STANDARD FIELD SERVICE BULLETIN

FSB Number	CHRAEFSB2016-27
Author	Tony Bryan
Date	08/29/2016
Subject	Moto G4, Moto G4 Plus - Speaker Audio
Model Affected	XT164x, XT162x
Level Of Repairs	Level 2

Figure 1.0 Speaker Contact Contamination

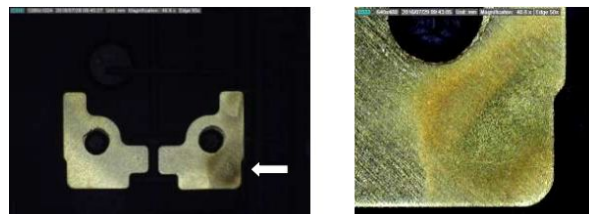
Engineering analysis determined issue was caused by contamination of the gold speaker contacts located on the Rear housing (p/n: 0101878600xW). See Figure 1.0 below. The source of the contamination was traced to an epoxy resin used in supplier assembly process.

Motorola is working with rear housing supplier to optimize assembly process controls to

prevent the contamination of the gold contacts.

1. Confirm issue by testing Speaker Audio functionality, using approved test procedures. Some slight twisting pressure applied to the housing may be required to help reproduce the issue , if confirmed:
2. Replace both the Earpiece Speaker (p/n: 50014061001) and the Rear Housing (p/n: 0101873600xW).
3. Reassemble and complete full functional testing to ensure proper repair.
